PRODUCT CHANGE NOTIFICATION COVERSHEET

CTS Part Number: Models 425, 403, 405

Product Description: Ceramic Quartz Crystal

Reason for PCN: Change notification for revised product marking format.

Model 425 [drawing 008-0332-0]

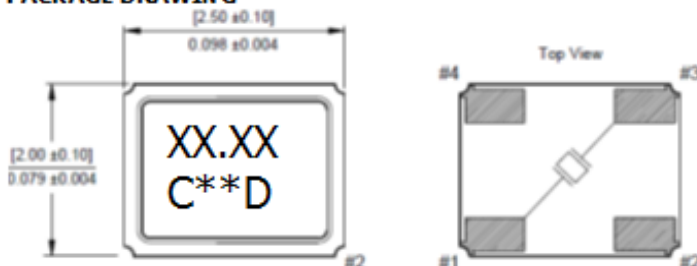
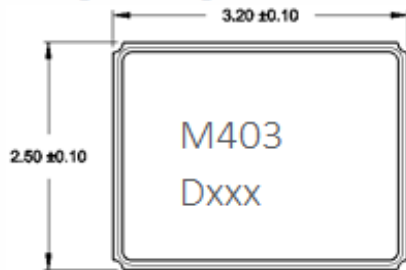
Description for Change: Product marking will change as follows.

Change From - Old Format, Revision C

1. XX.XX – Frequency in MHz.
2. C – CTS and Pin 1 identifier.
3. ** – Manufacturing Site Code.
4. D – Date code. See Table I for codes.

Change To - New Format, Revision D

1. M425 – CTS Model series.
2. D – Date code. See Table I for codes.
3. xxx – Frequency code, 3-digits frequencies below 100MHz.
[See document 016-1454-0, Frequency Code Tables].

Model 403 [drawing 008-0288-0]

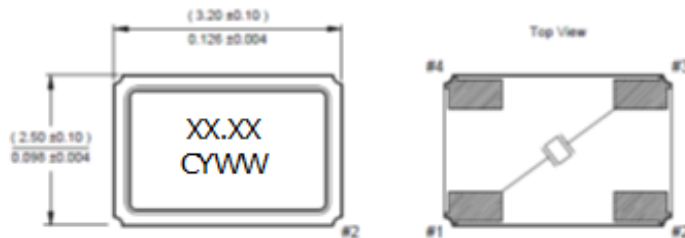
Change From - Old Format, Revision G

1. XX.XX – Frequency marked with 2 significant digits after the decimal.
2. C – CTS and Pin 1 identifier.
3. YWW – Date Code, Y – Last Digit of Year, WW – Week.

Change To - New Format, Revision H

1. M403 – CTS Model series.
2. D – Date code. See Table I for codes.
3. xxx – Frequency code, 3-digits frequencies below 100MHz.
[See document 016-1454-0, Frequency Code Tables].

Model 405 [drawing 008-0253-0]

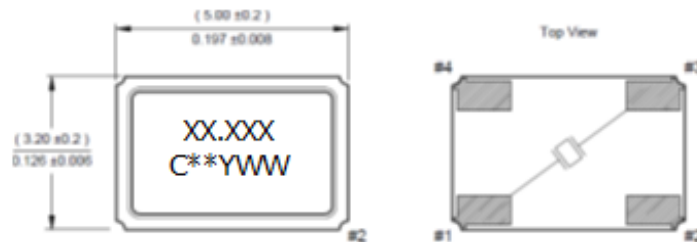
Change From - Old Format, Revision H

1. XX.XXX – Frequency marked with 3 significant digits after the decimal.
2. C – CTS and Pin 1 identifier.
3. ** - Manufacturing Site Code.
4. YWW – Date Code; Y – Last Digit of Year, WW – Week.

Change To - New Format, Revision I

1. M405 – CTS model.
2. C – CTS.
2. D – Date Code. See Table I for codes.
3. xxx – Frequency Code.
3-digits, frequencies below 100MHz.
[See document 016-1454-0, Frequency Code Tables.]
